PILATUS AIRCRAFT LTD, STANS, SWITZERLAND

SERVICE BULLETIN

Service Bulletin No: 27-005 Ref No: 51

FLIGHT CONTROLS - SPOILERS LUBRICATION OF THE SPOILER CONTROL ROD-TO-SPOILER ACTUATOR CONNECTION-BOLT

Lubrication of the Bolt Figure 1

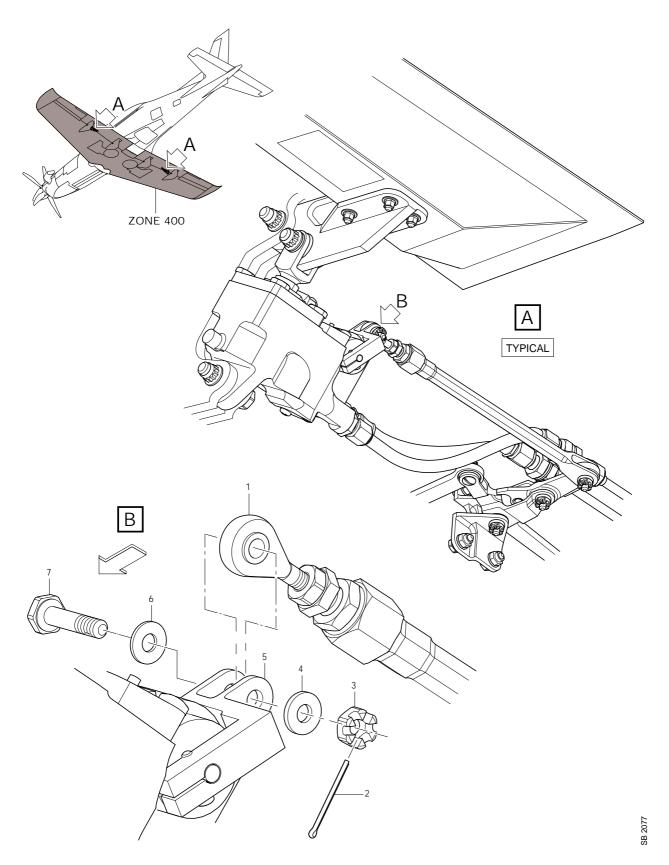
B. Lubrication of the Bolt (Ref. Fig. 1)

- (1) Remove and discard the cotter pin (2).
- (2) Remove the nut (3), the washer (4), the washer (6) and the bolt (7) and disconnect the spoiler control rod (1) from the spoiler actuator lever (5).
- (3) Clean the bolt (7), the washers (4 and 6) and the nut (3) with the absorbent paper (Material No. P02-031) made moist with the solvent (Material No. P01-010).

CAUTION: DO NOT LET THE SOLVENT (MATERIAL NO. P01-010) GO INTO THE BEARING OF THE ROD-END OF THE SPOILER CONTROL ROD (1). IT WILL CAUSE THE BEARING TO BECOME DRY AND SEIZE.

- (4) Clean the rod-end of the spoiler control rod (1) with the absorbent paper (Material No. P02-031) made moist with the solvent (Material No. P01-010).

- (5) Let the rod-end of the spoiler control rod (1), the bolt (7), the washers (4 and 6) and the nut (3) dry.
- (6) Put the spoiler control rod (1) in position in the spoiler actuator lever (5).

- (7) Apply a layer of the grease (Material No. P04-028) to the plain part of the bolt (7).
- (8) Install the bolt (7), the washer (4), the washer (6) and the nut (3).

- (9) Tighten the nut until there is 0.4 mm (0.016 in.) axial play on the bolt (7).
- (10) If necessary, continue to tighten the nut (3) until the hole for the cotter pin (5) aligns with the next cut-out in the nut (3).

- (11) Make sure the axial play is more than 0.1 mm (0.004 in.).
- (12) Safety the nut (3) with the cotter pin (2).
- (13) Do Steps 3.B.(1) thru (12) for the other spoiler.
